**Structural Calculations**  
**Roof Seismic Strengthening - Partial**  
**Concrete Tilt-up Building**  
**1918 E Glenwood Place (Bldg D)**  
**Santa Ana, CA**

## TENANT IMPROVEMENT PLAN CHECK COMMENTS

<b>PLAN CHECK NO:</b>	10173635,6,7		
<b>PROJECT ADDRESS:</b>	1831 S Ritchey St, 1917 E St. Andrews AND 1918 E Glenwood Pl.		
<b>PLAN CHECK ENGINEER:</b>	Kwak, Jason	<b>TEL: 714</b>	647-5866
		<b>FAX: 714</b>	647-5897
<b>TYPE OF CONSTRUCTION:</b>	V B		
<b>OCCUPANCY CLASSIFICATION(S):</b>	B, S-1		
<b>PLAN CHECK DATES:</b>		<b>REMARKS/RECHECK ITEMS:</b>	
<b>APPLICATION</b>	11/7/2011	_____	
<b>INITIAL REVIEW</b>	11/23/2011	_____	
<b>EXPIRATION</b>	5/5/2012	_____	
<b>RECHECKS:</b>	1.	<b>PROJECT APPLICANT CONTACT PERSON:</b>	
	2.	Michael Santillan	
	3.	<b>TEL:</b>	(949)716-9990
<b>VALUATION:</b>	\$30,000.00	<b>FAX:</b>	_____
<b>FLOOD ZONE:</b>	X-0602320277J	<b>EMAIL:</b>	michael.santillan@nationaleng.com

RE: 1918 E. Glenwood Place  
Plan Check # 10173637

SHEET NUMBER:

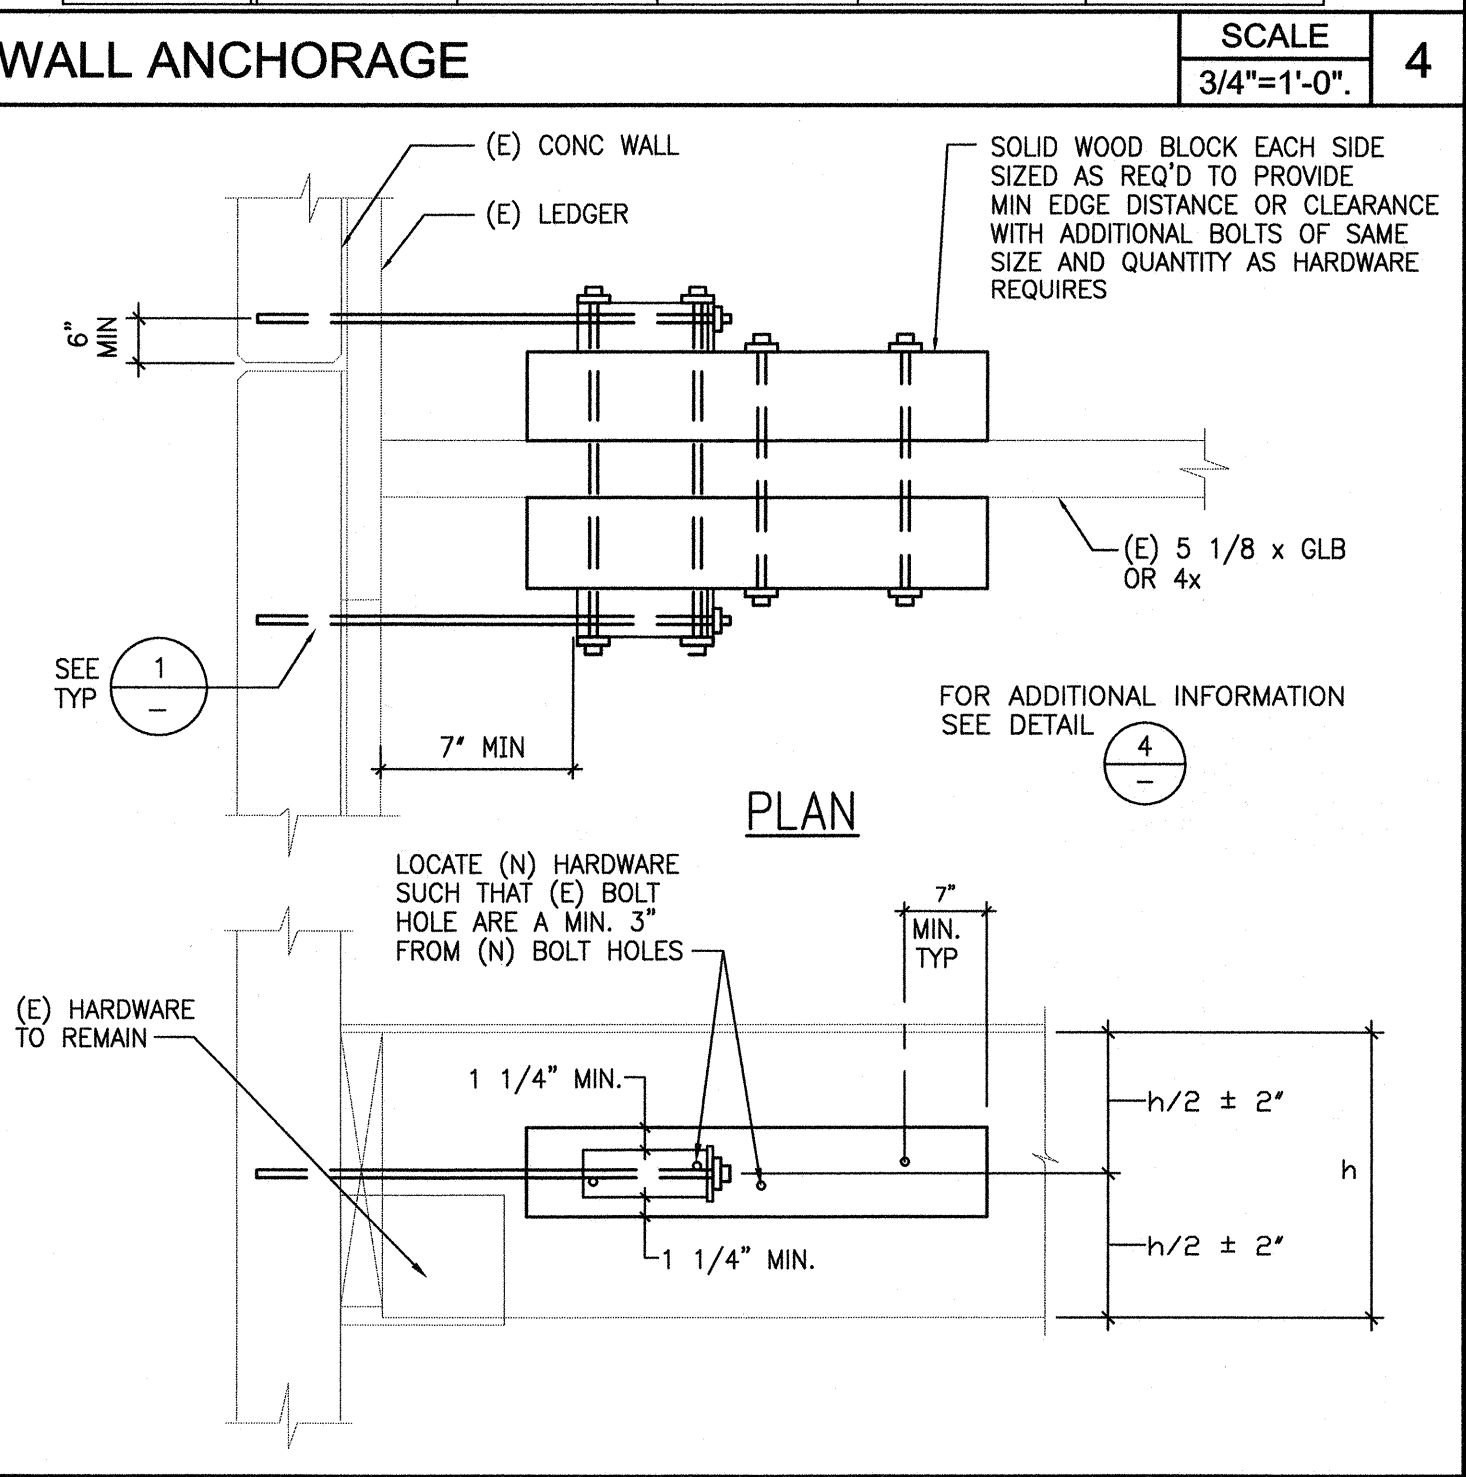
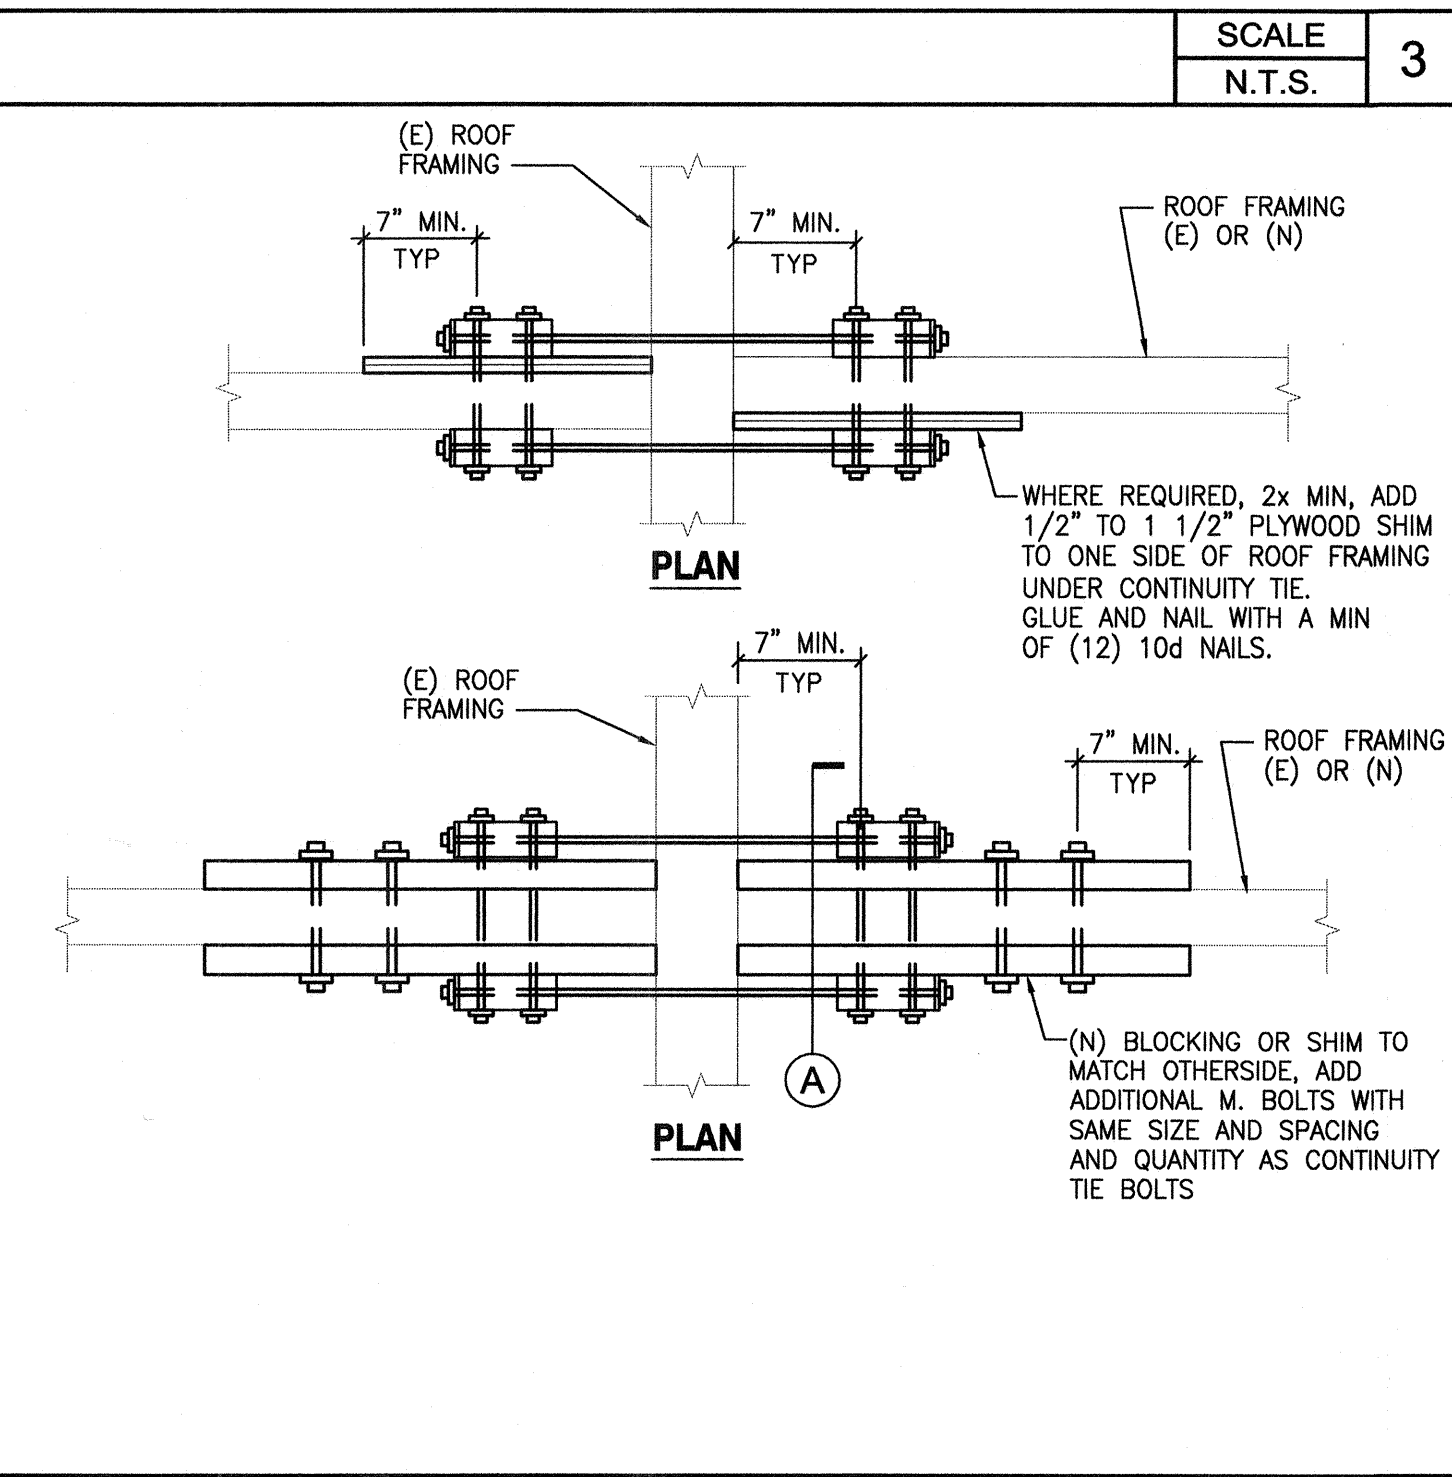
*The drawings/information submitted for Building Safety Division review is incomplete.....-  
Provide required disable accessible upgrade proposal with plans.*

*It is the project designer's/property owner's responsibility to show compliance on the drawings with all applicable Federal and State Accessibility Standards*

*Drawings submitted to the Building Division for review shall provide the following information to insure compliance with CBC Section 1134B/Chapter 11B:*

*Priority shall be given to those elements that will provide the greatest access in the above order.*

**-Response: See sheet A-1, which shows proposed ADA upgrades**

**-Response: Proposed ADA upgrades are now shown on the new sheet A-1**

**-Response: see sheet A-1**

**-Response: see sheet A-1**

SHEET NUMBER:  
**S-1**

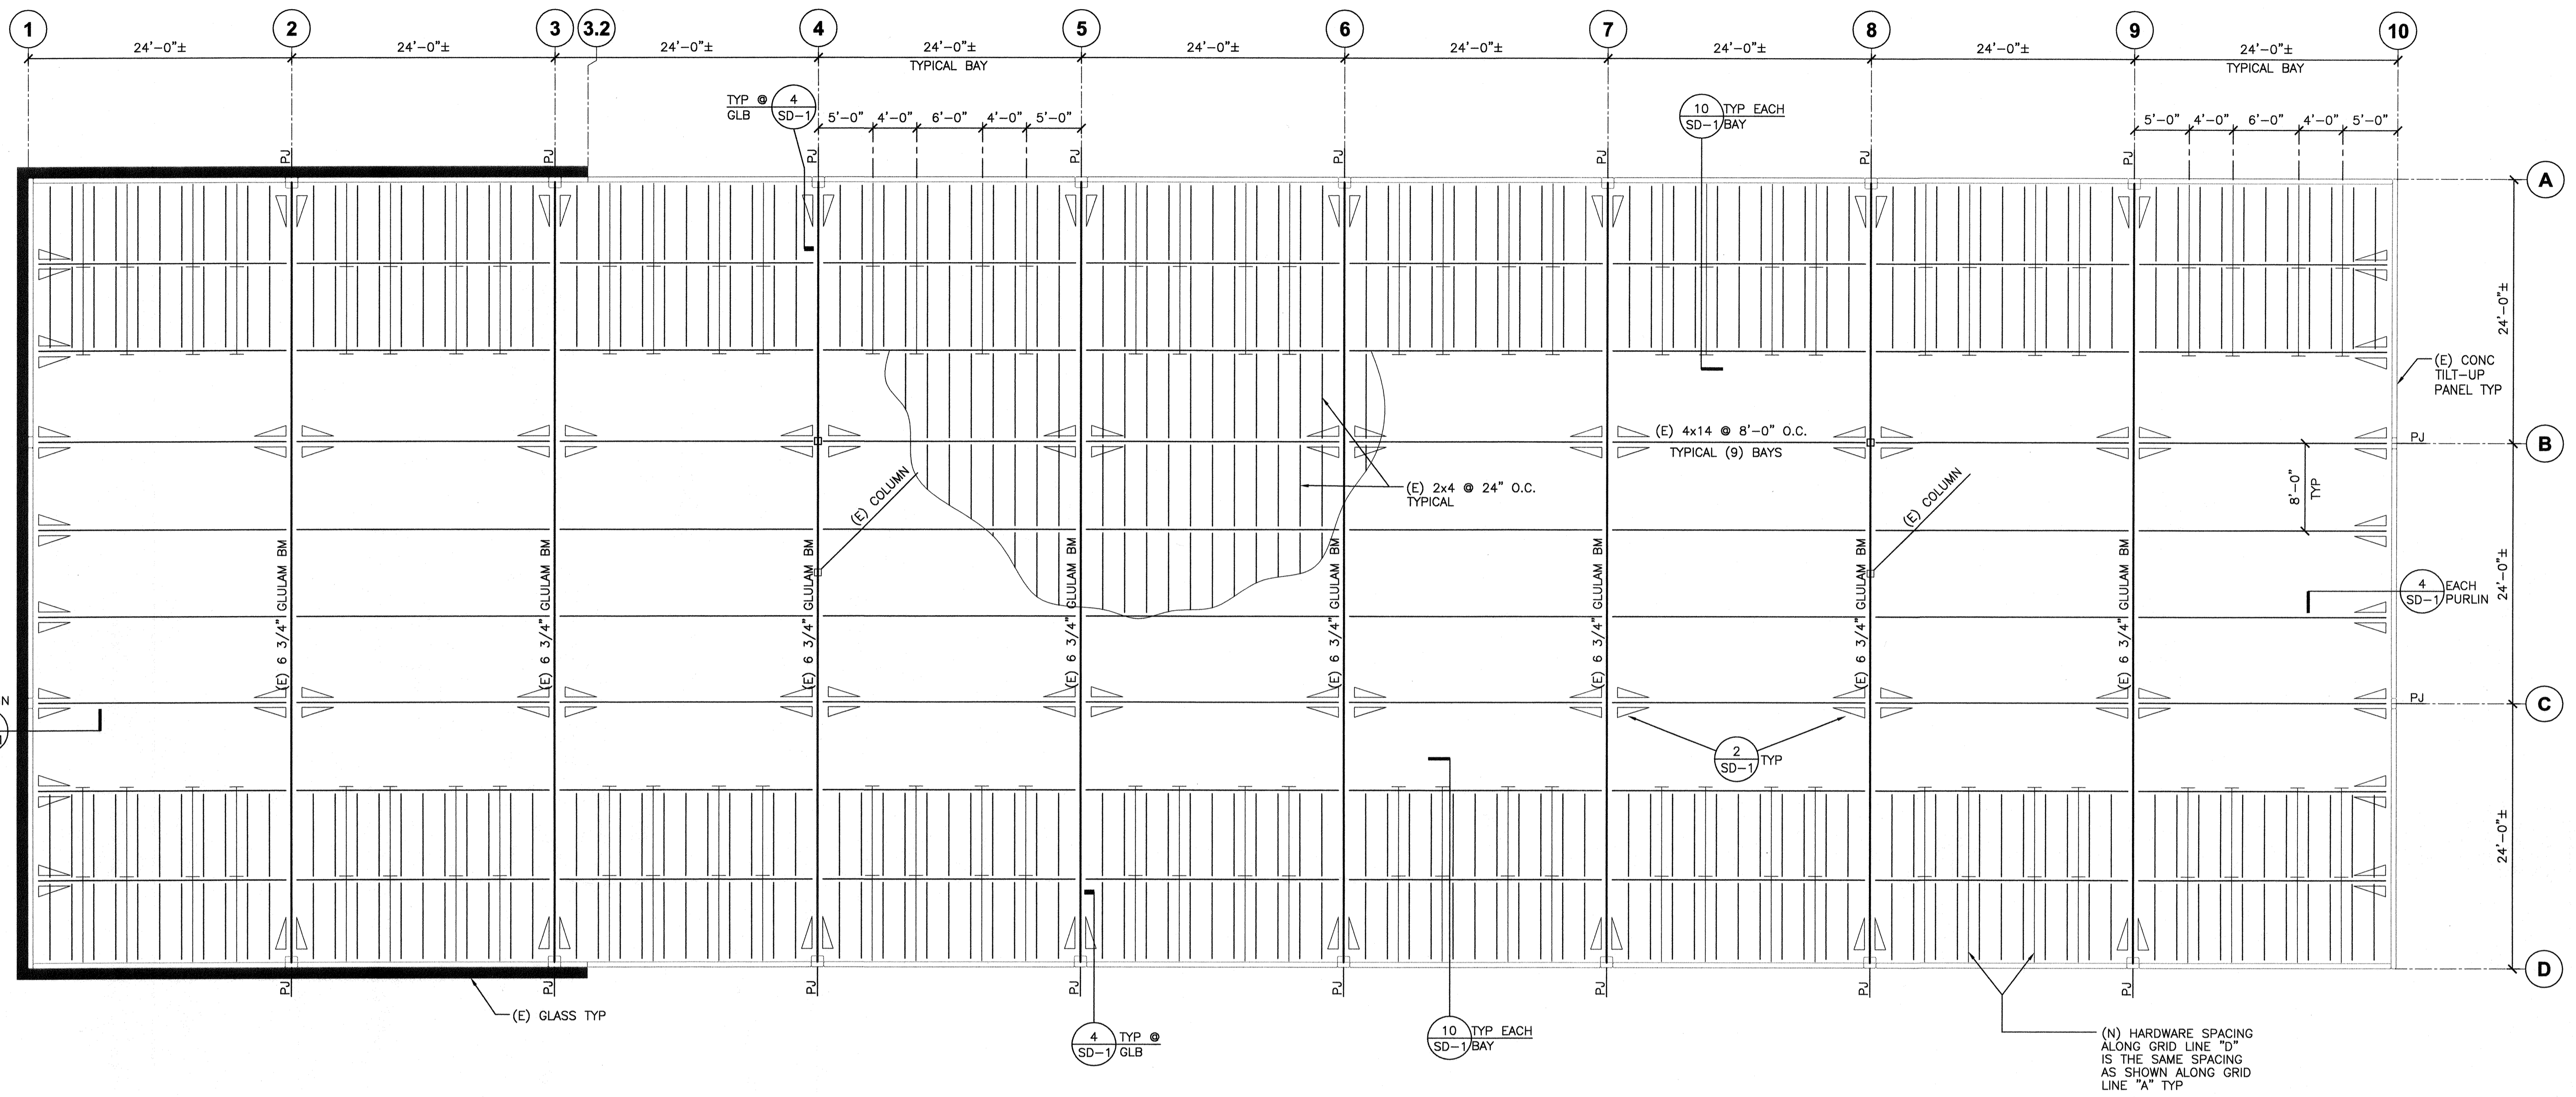
*Provide ICC or LARR listing number on plans for Zone 4 hardware*

**Response:** Complied. The LARR is 25334 and approved as of November 1, 2011. See structural plans detail 4/SD-1. As part of this approval, Zone4 revamped their product line and developed new capacities which I have attached.

- The old continuity tie T2-44-6 is now a T2-44-5 with greater capacity (Details 2 & 6/SD1).
- The old wall anchor T2-24-6 is now a T2-24-4 with greater capacity (Detail 4/SD1).
